DANE COUNTY DEPARTMENT of PUBLIC WORKS, HIGHWAY and TRANSPORTATION

RFB NO. 313083 - ADDENDUM NO. 3

CONSTRUCTION OF EAST HIGHWAY GARAGE – SALT STORAGE FACILITY (BID PACKAGE A) AND MEDICAL EXAMINER OFFICE BUILDING (BID PACKAGE B)

**DEPARTMENT OF PUBLIC WORKS,
HIGHWAY & TRANSPORTATION
3562 COUNTY HIGHWAY AB
MCFARLAND, WISCONSIN**

PLAN NORTH
 SCALE: As Indicated
M-003

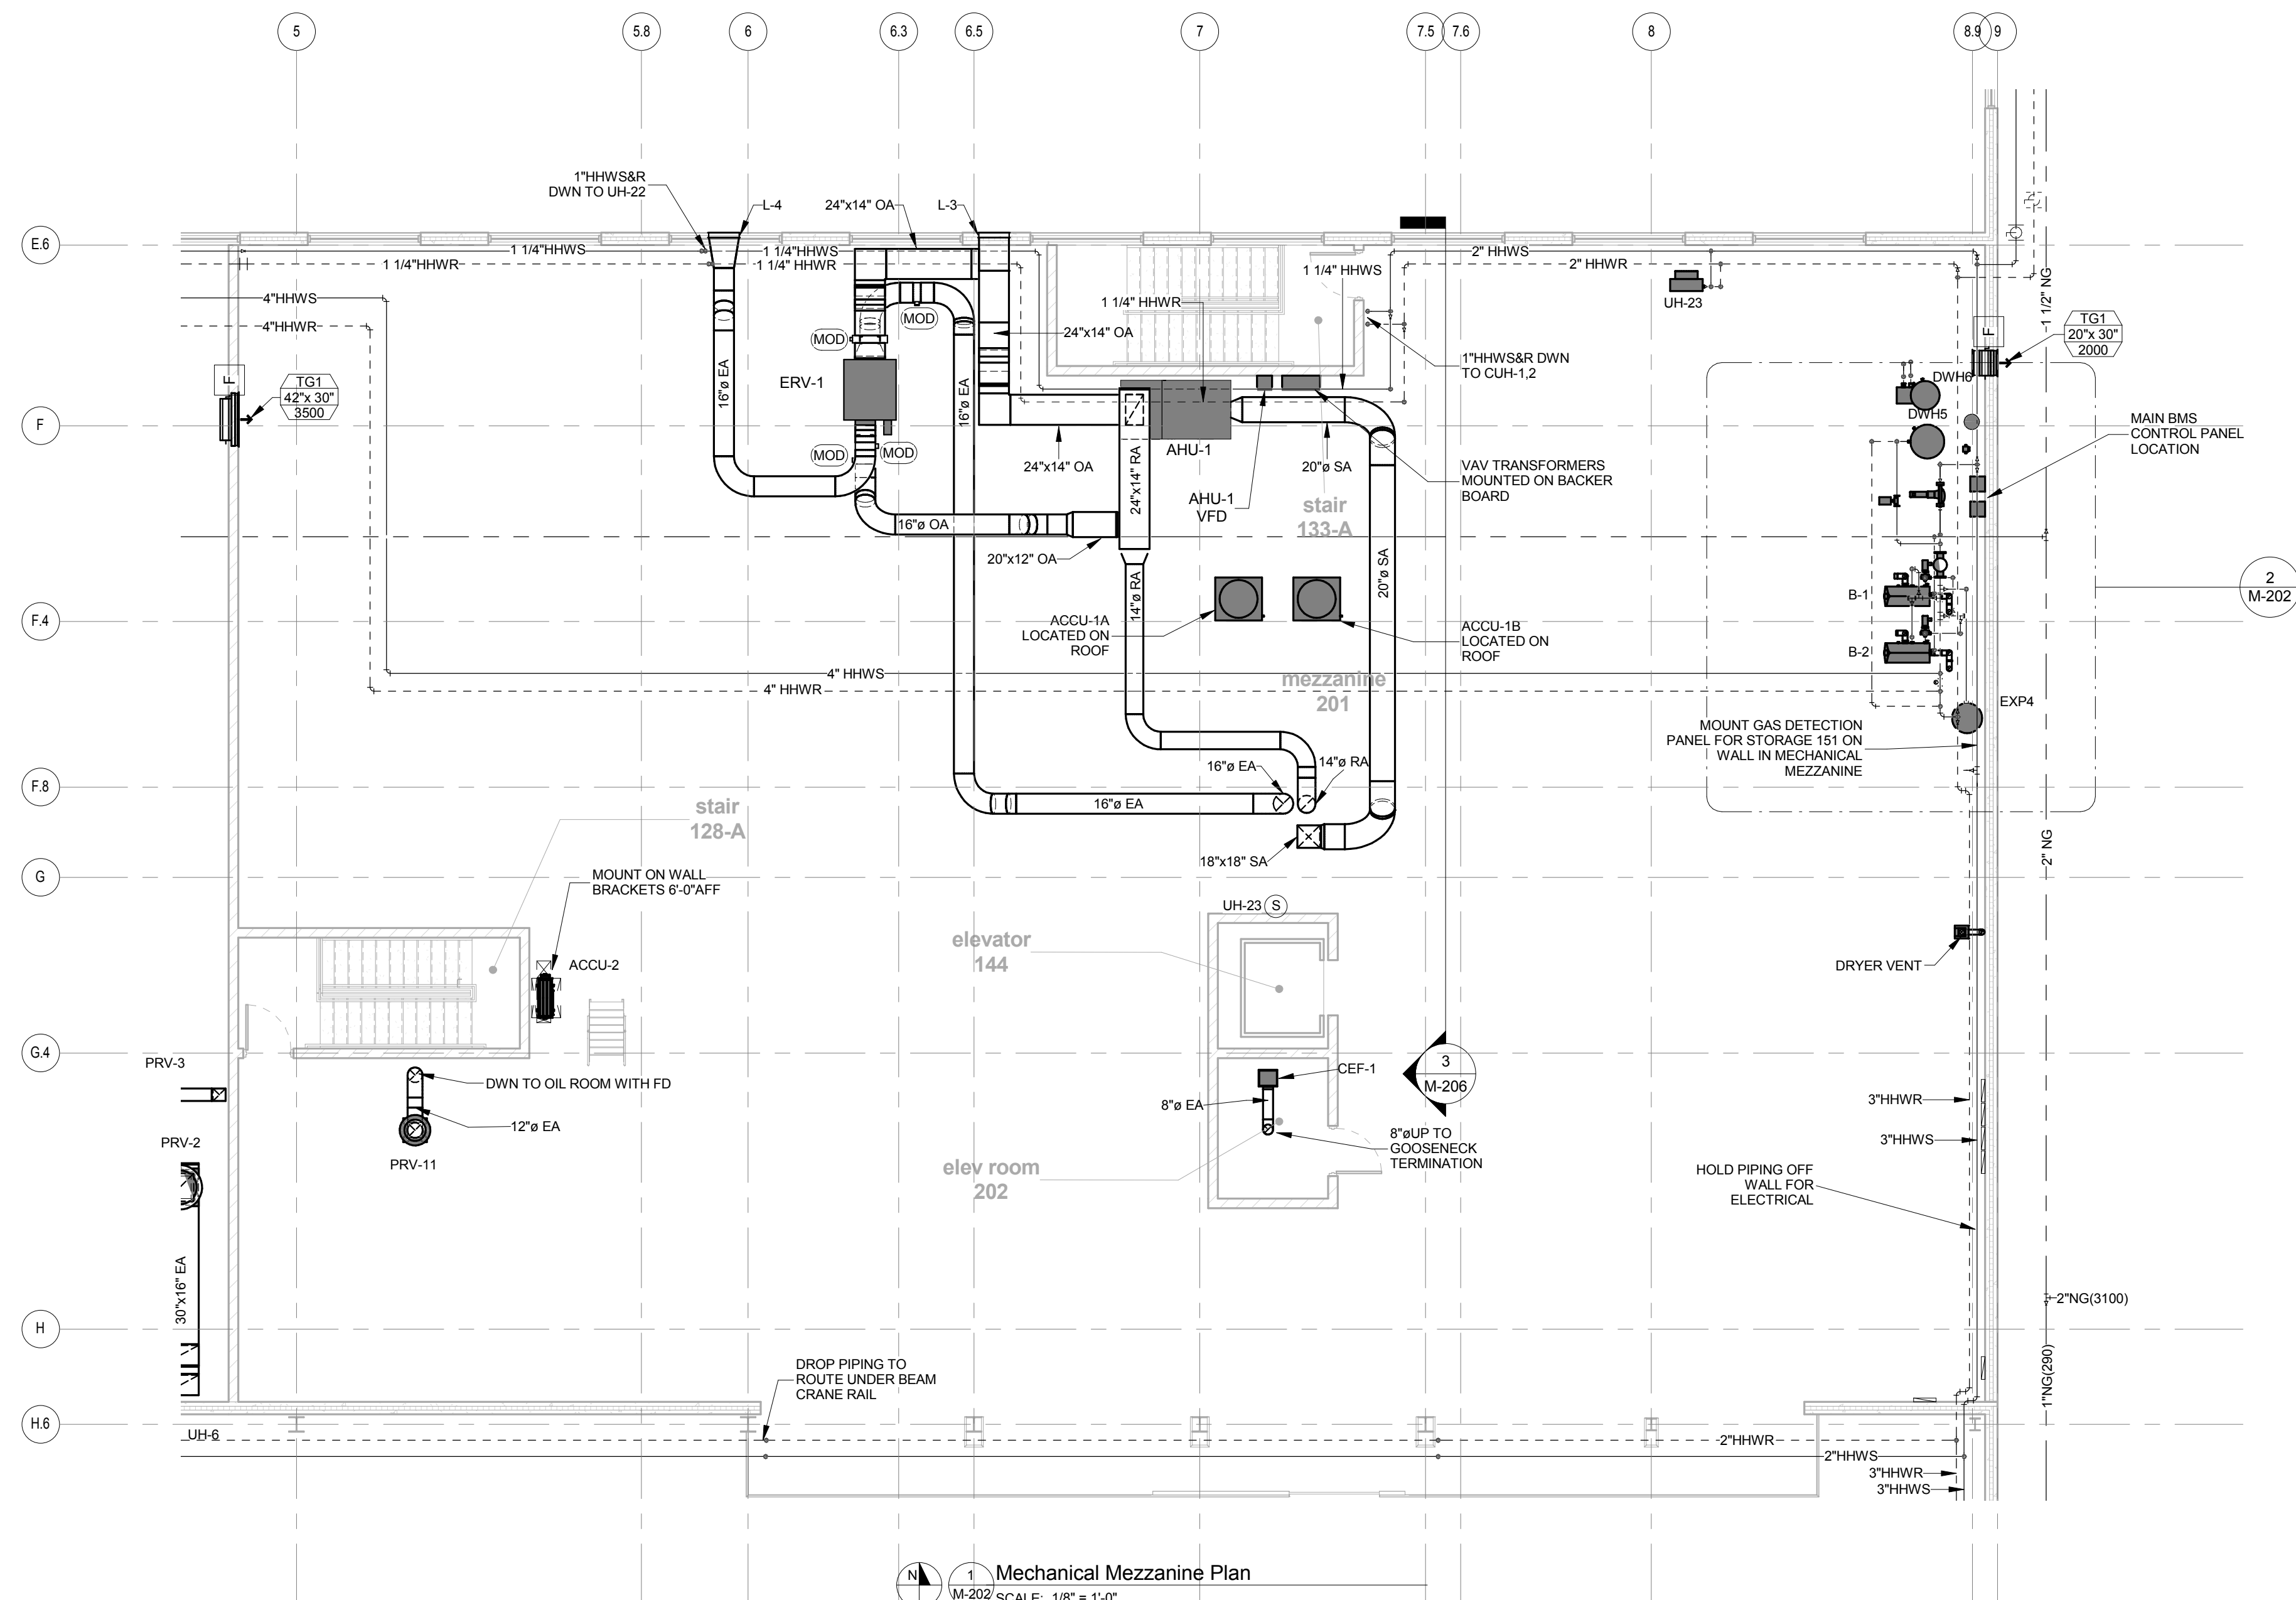
1. Site piping details relocated to Sheet M-003.

Sheet E-210 – Fire Pump Building Plan, Emergency Generator

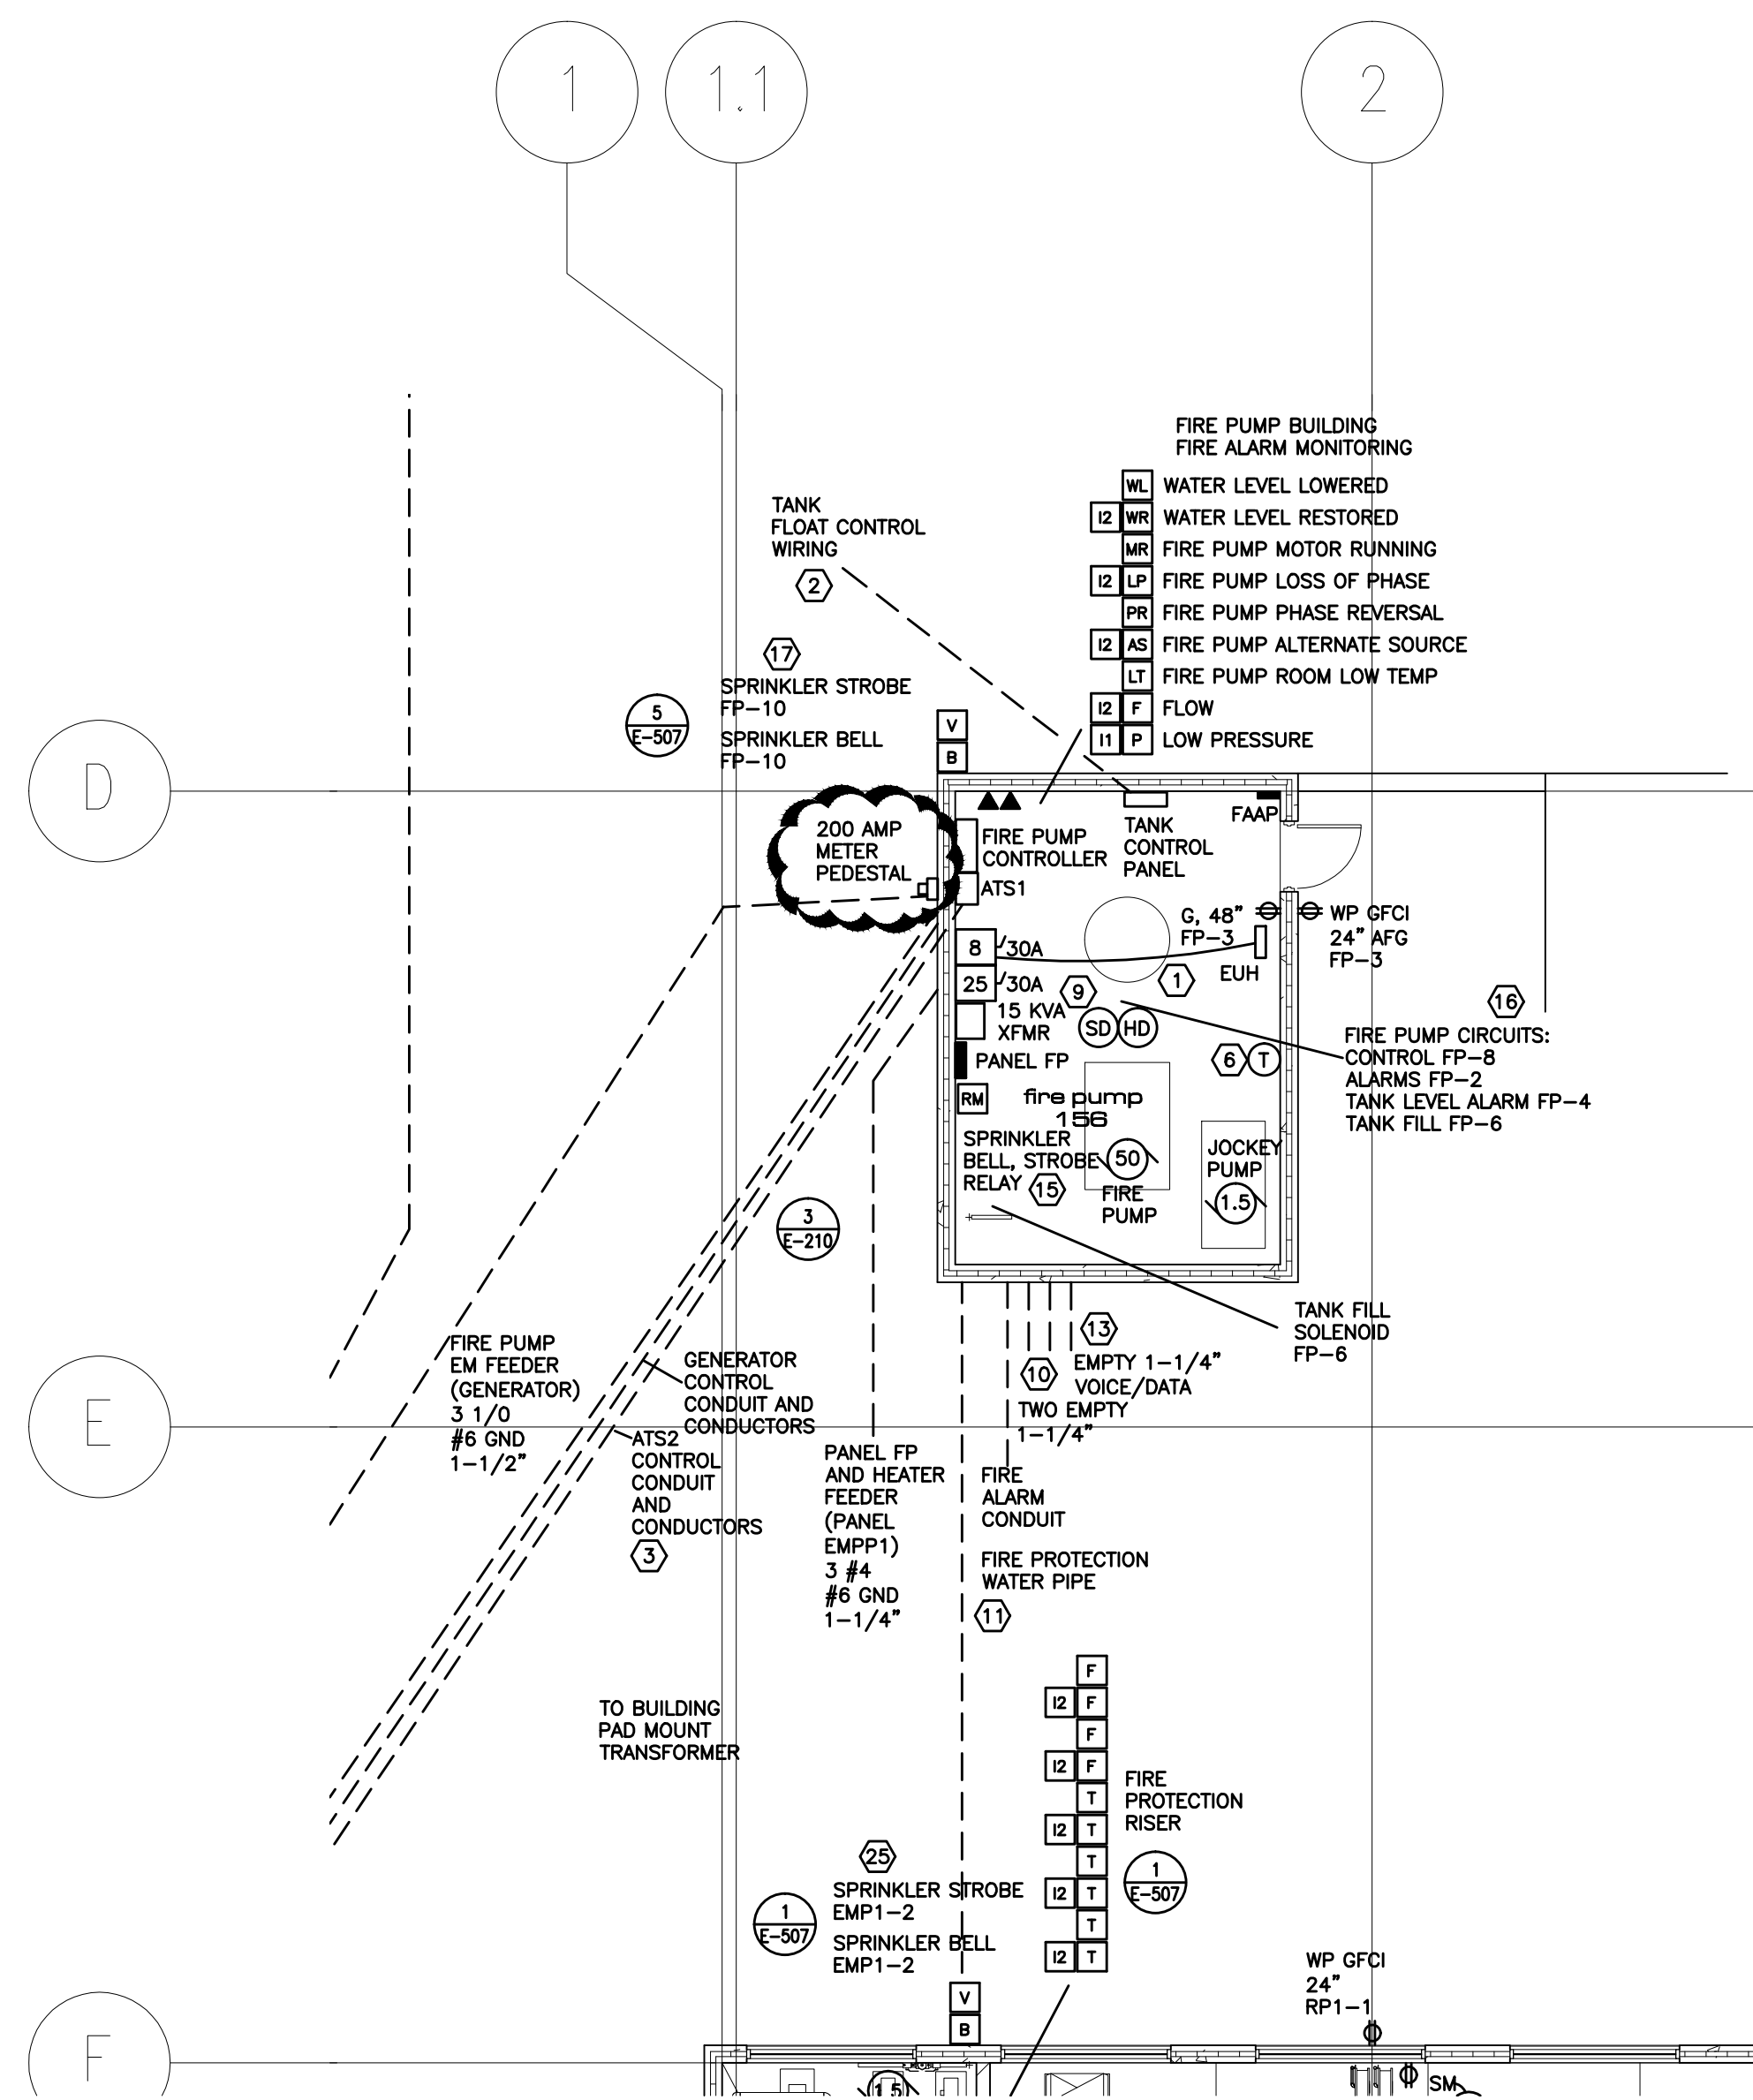
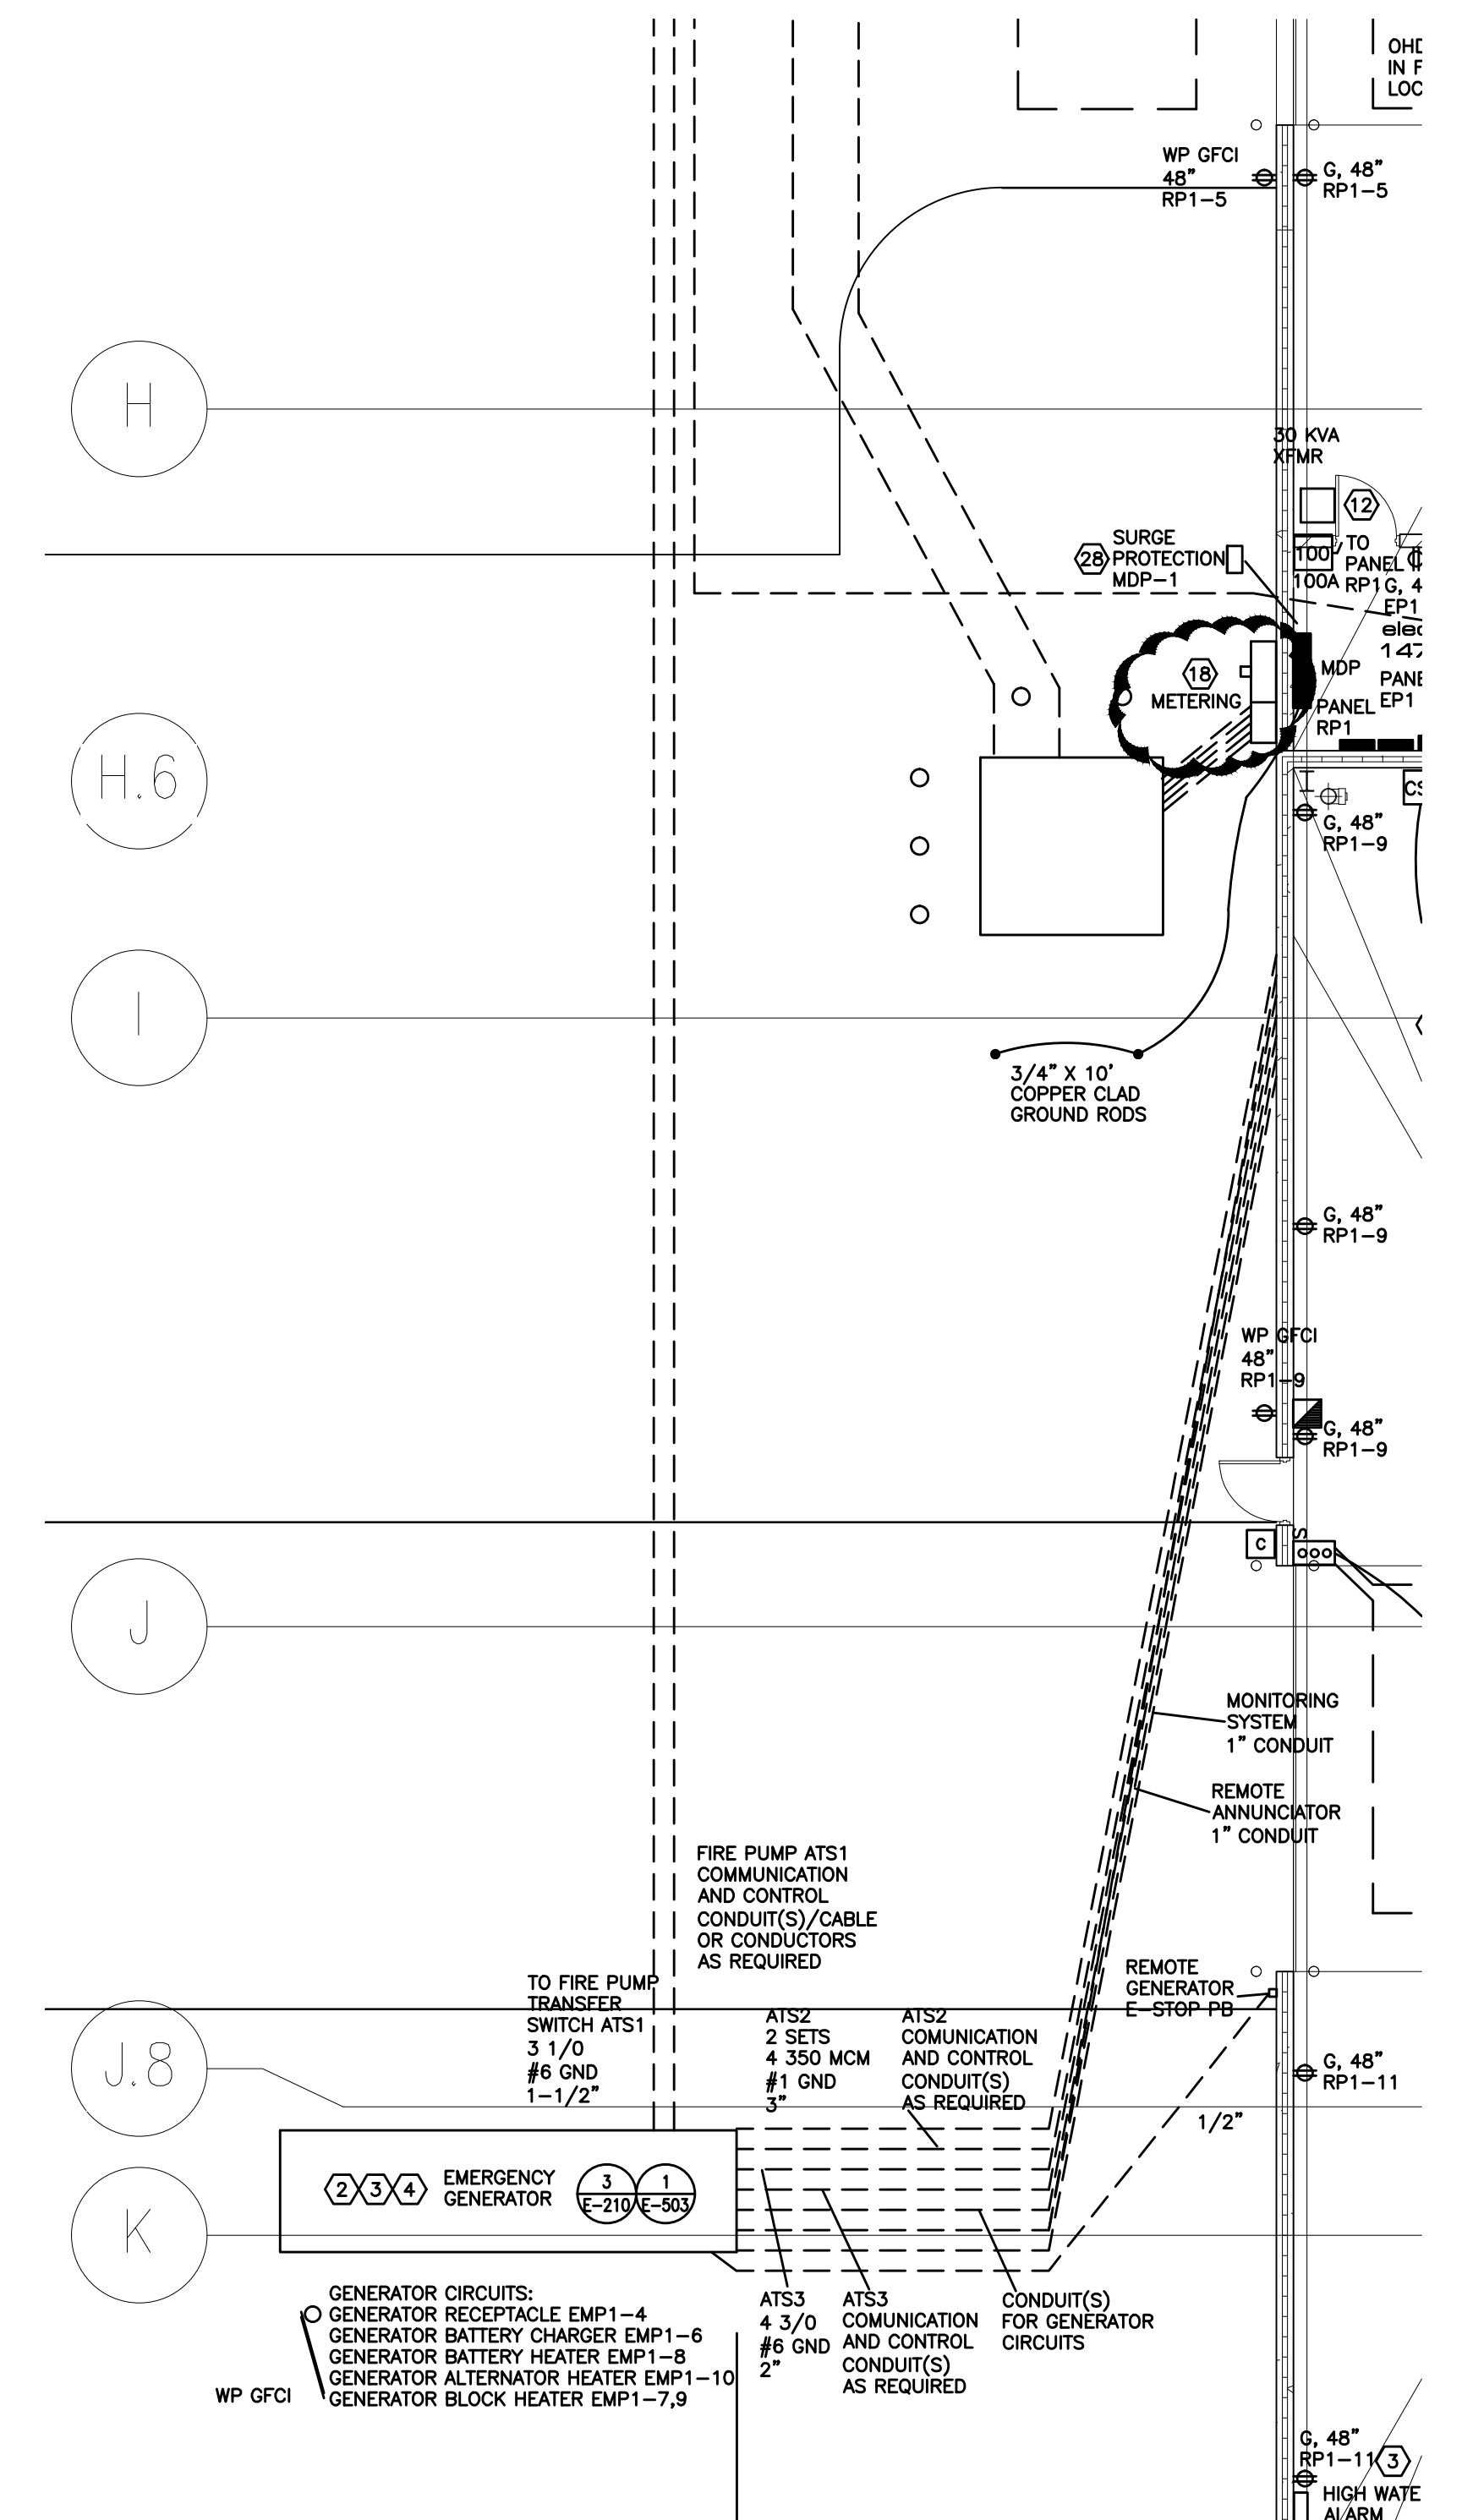
1. Revised Detail 2 shows revised metering for the highway facility building. The Highway Facility metering was changed to a termination compartment with metering. See revised sheet included in this addendum.
2. Revised Detail 3 shows revised metering for the fire pump building. The 400 Amp fused disconnect was removed and a 200 Amp meter was added. See revised sheet included in this addendum.
